Official Notification Federal Boat Safety Act Reverse Lock Link Rod Replacement - 15 (4-Stroke)

1998 15 (4-Stroke)

USA S/N 0G590000 thru 0G736819

57141

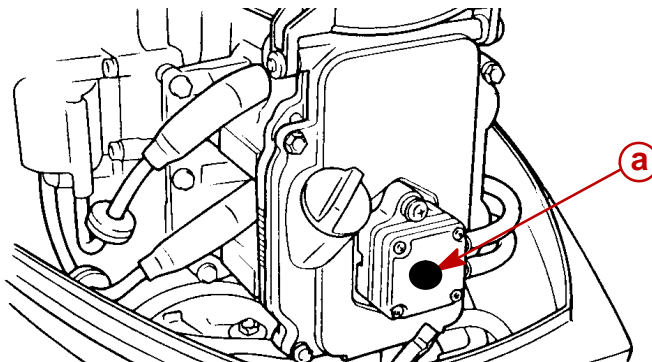
Outboards listed require replacement of the reverse lock link rod prior to operation. Affected units were assembled with reverse lock link rods which can come in contact with the lower cowl pan and deflect (bend) out of adjustment. This misadjustment can engage the reverse lock hooks in forward gear and not allow the outboard to be tilted up. Should the lower unit strike a submerged object while the boat is in forward gear, this condition could cause damage to the reverse lock mechanism and/or at slower boat speeds result in a sudden unexpected boat stoppage.

- a** - Upper Reverse Lock Link Rod - Early design (actuated by a cross pin) making contact with lower cowl.
- b** - Reverse Lock Link Rod Kit (p/n 858338A3) - Current design, actuated by reverse hook guide.
- c** - Reverse Hook Guide

Replace the existing reverse link rod assembly, as outlined in the installation instructions supplied with Reverse Lock Link Rod Kit (p/n 858338A3).

Qty. 1 p/n 858338A3 Reverse Lock Link Rod
